From: Brehm, Tami
Sent: Monday, April 6, 2026 11:06 AM
To: Bailey, Maxwell; Carfora, Cory; Bair, Alexander; Peters, Benjamin; Carriere, Casey
Subject: RE: Water Elevation Mar-4 BUT-SR126 Retaining Wall 250189 BUT116204

As Beaty bright up during out PreCon last week, if they choose to perform the construction joint in the wall (shown Sec B-B sheet 28) can we provide them with a Lap detail/length for the W510 thru W513 and W806 thru W809 bars.

Please see below RFI concerning steel coverage on the BUT-126 retaining wall.

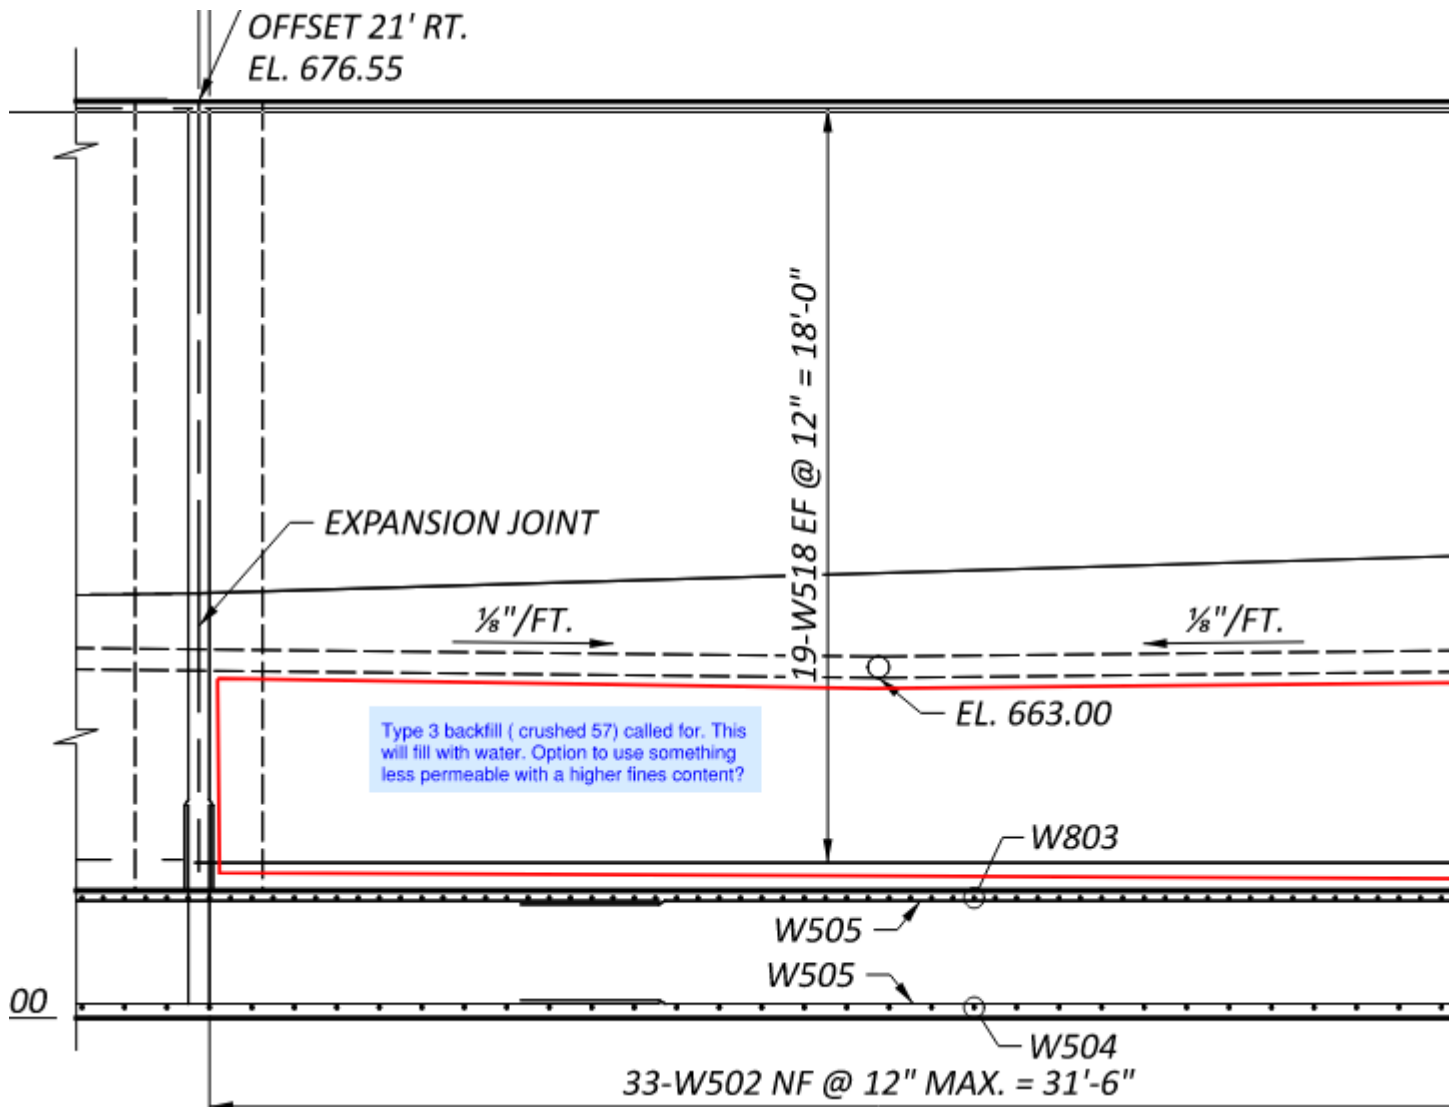
Your statement about water collecting in this region is correct and we understood this during design. While this is acceptable, we have no objection to replacing the backfill in this region with material with a higher fines content.

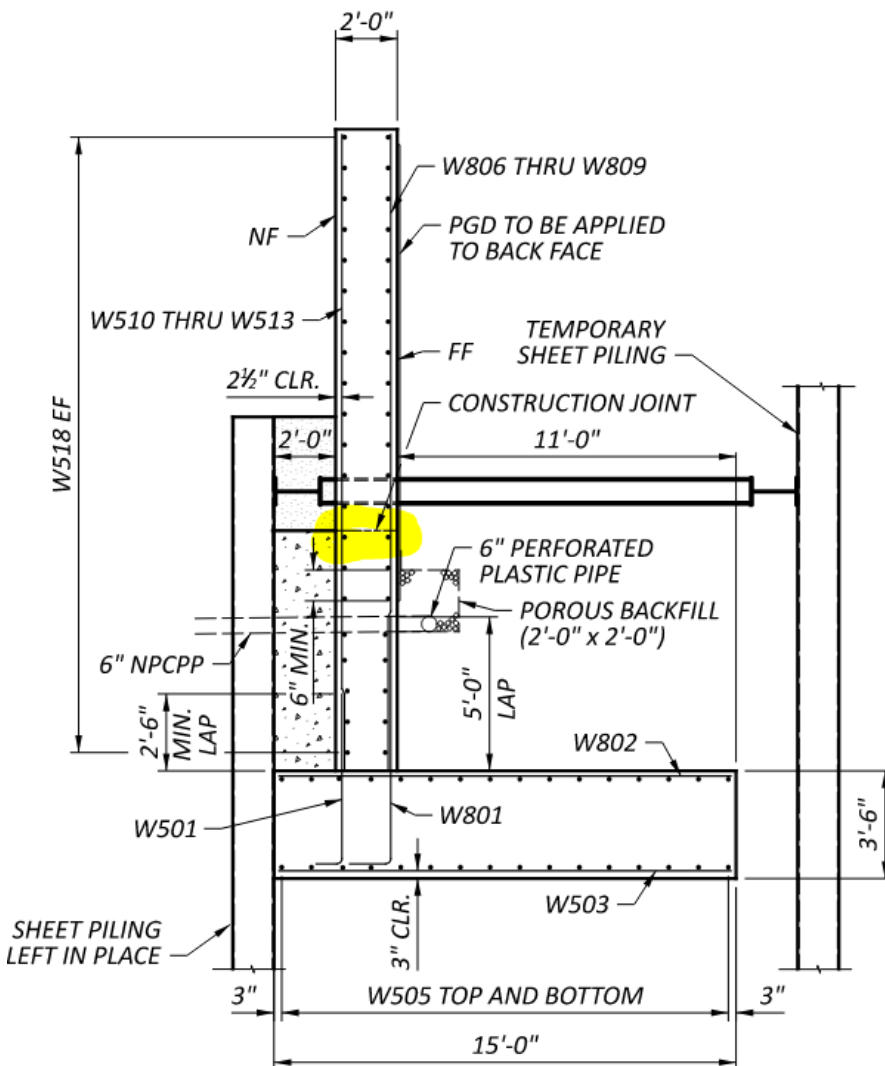
Per BDM Figure 304-4 (below) The tension lap splice for 2.5 inches of cover is shown for number 5 and 8 bar in column B. I'm good with specifying column A if that's the preference.

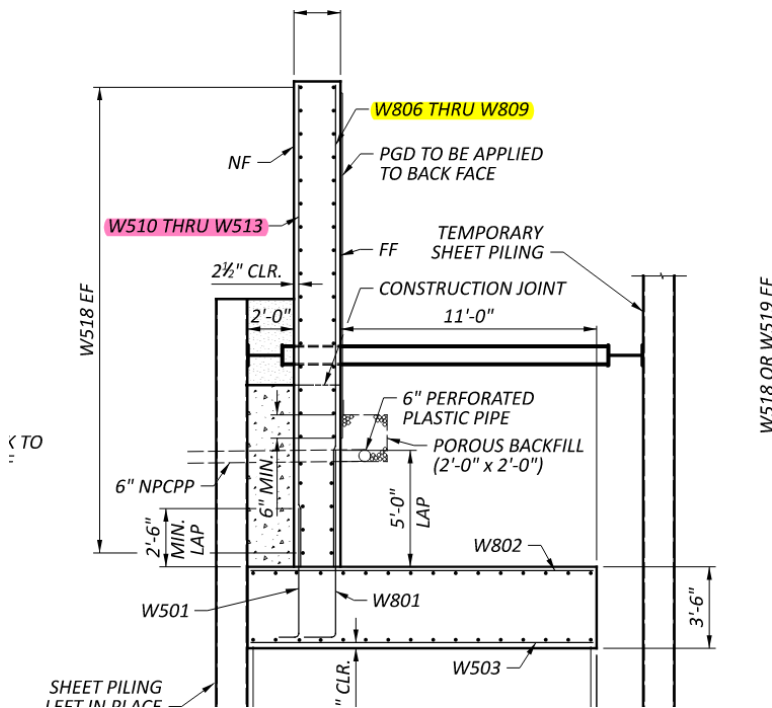
The W806 thru W809 bars highlighted above are shown as a series of graduated lengths on the steel table on sheet 31 since the wall height varies, but the W510 thru W513 bars are shown as uniform lengths in the table even though the wall height is not uniform.

Thanks for the clear explanation. It's not critical that the steel extends to the top of the wall on the NF. We can live with it. If they choose to fabricate it to match, I am also good.

SECTION B-B
STA. 12+21.00± TO 13+58.00±

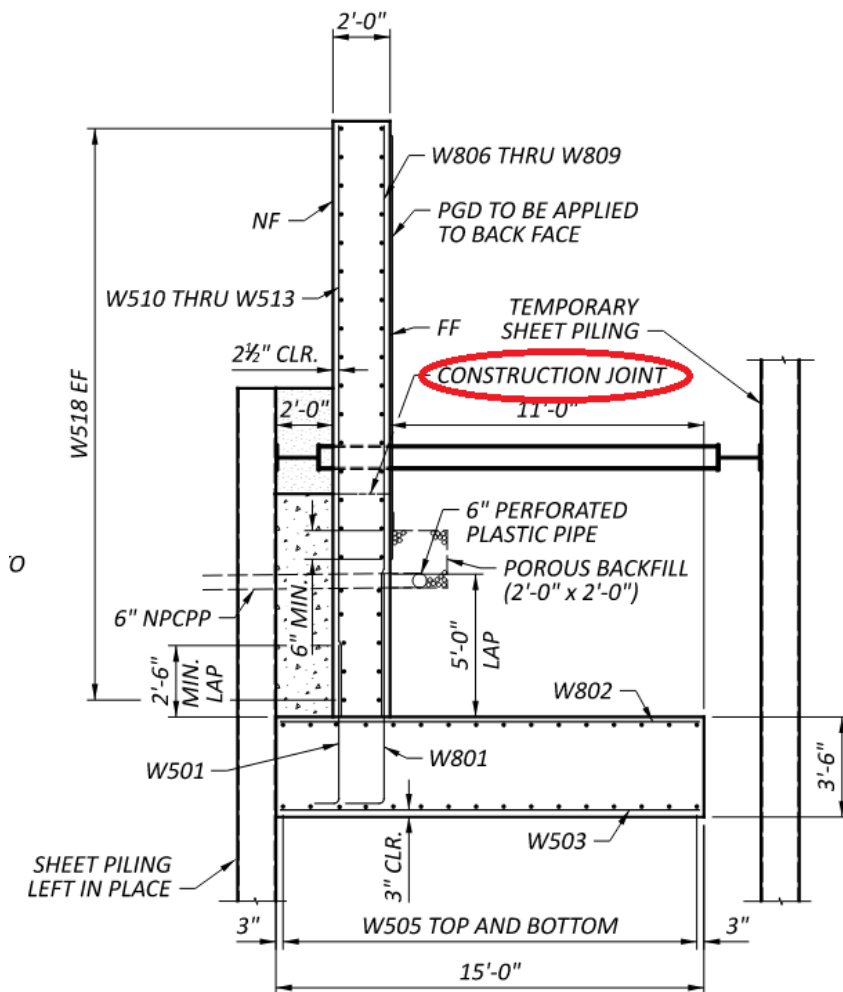
Question 2: Was about the construction joint and vertical steel. Their preference is to pour full height and avoid the construction joint and just cut off the waler and leave in place. Alternatively, pour to construction joint and splice on steel. We would need lap splice lengths for this.

SECTION B-B
STA. 12+21.00± TO 13+58.00±

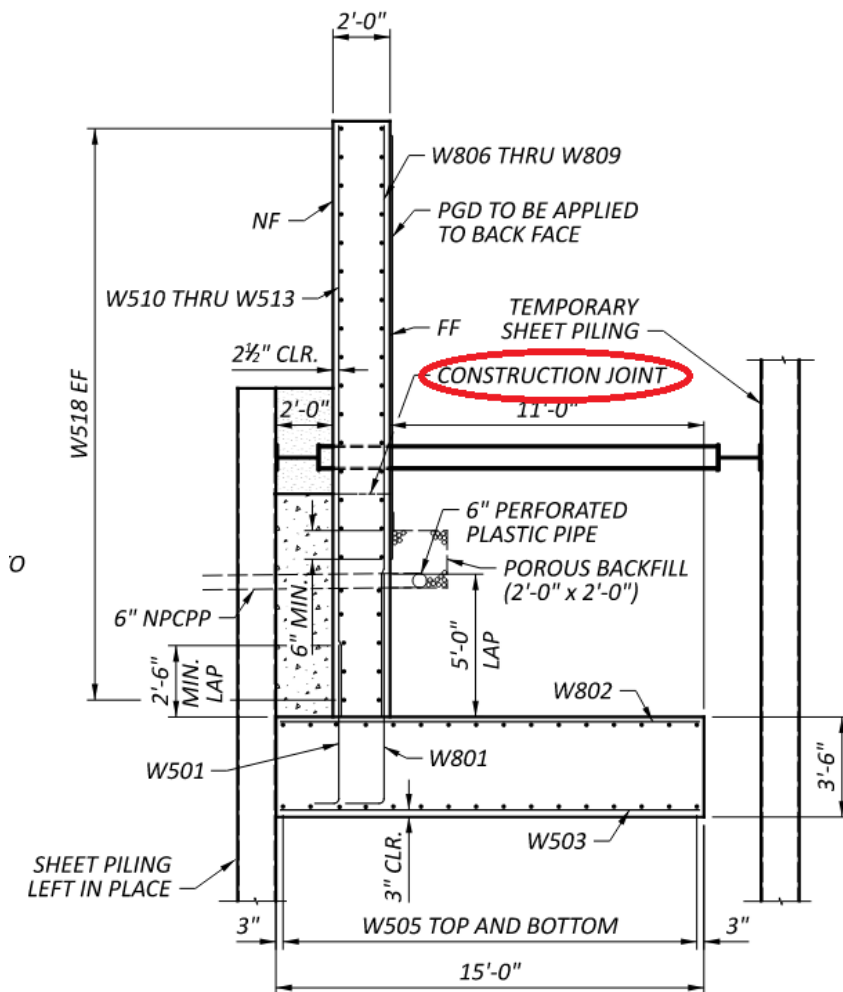
Question 2: Was about the construction joint and vertical steel. Their preference is to pour full height and avoid the construction joint and just cut off the waler and leave in place. Alternatively, pour to construction joint and splice on steel. We would need lap splice lengths for this.

SECTION B-B
STA. 12+21.00± TO 13+58.00±

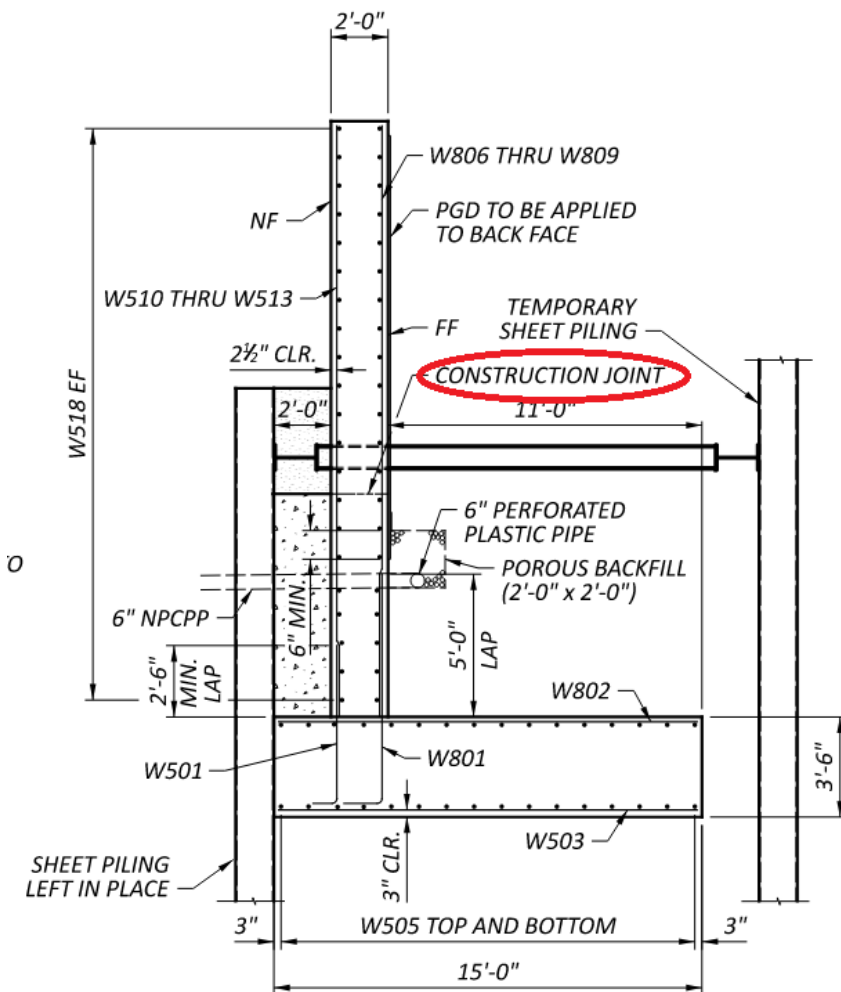
Question 2: Was about the construction joint and vertical steel. Their preference is to pour full height and avoid the construction joint and just cut off the waler and leave in place. Alternatively, pour to construction joint and splice on steel. We would need lap splice lengths for this.

SECTION B-B

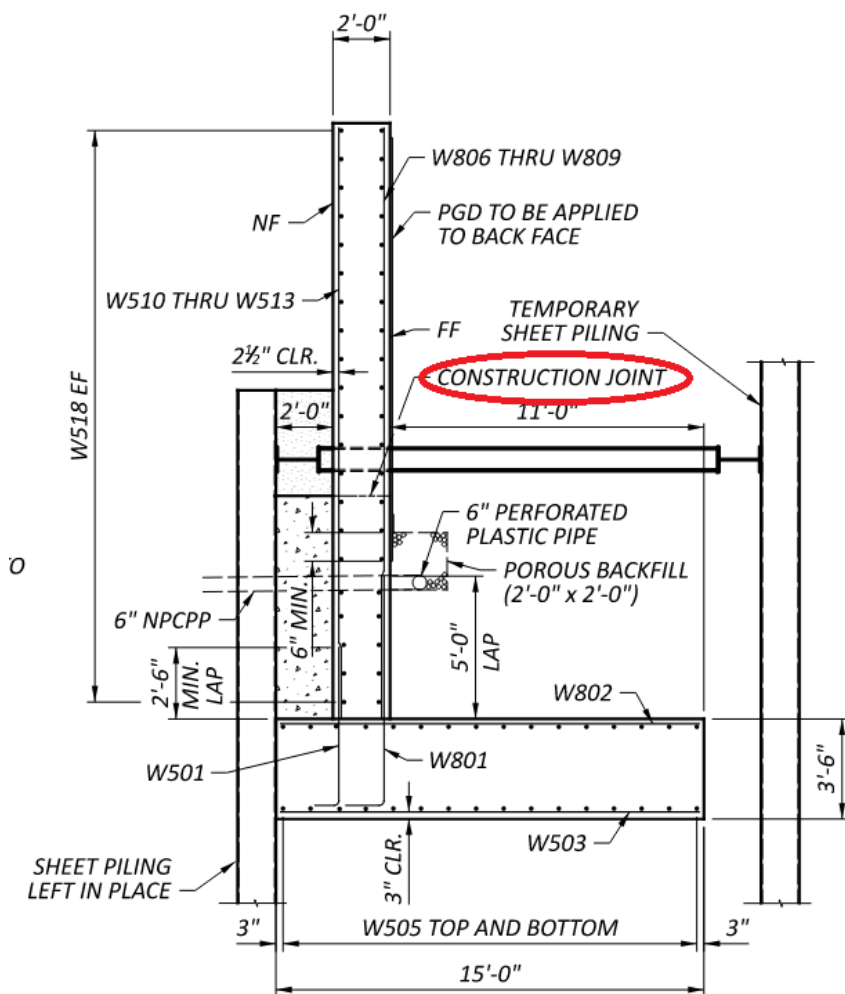
Question 2: Was about the construction joint and vertical steel. Their preference is to pour full height and avoid the construction joint and just cut off the waler and leave in place. Alternatively, pour to construction joint and splice on steel. We would need lap splice lengths for this.

SECTION B-B
STA. 12+21.00± TO 13+58.00±

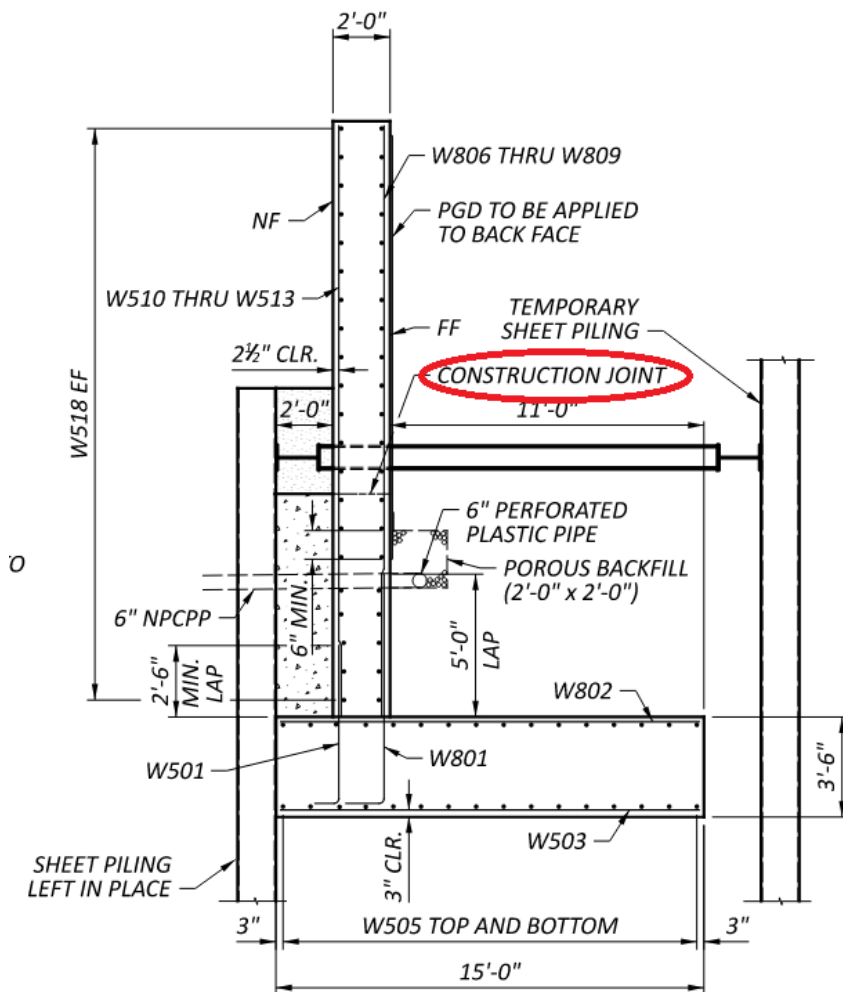
Question 2: Was about the construction joint and vertical steel. Their preference is to pour full height and avoid the construction joint and just cut off the waler and leave in place. Alternatively, pour to construction joint and splice on steel. We would need lap splice lengths for this.
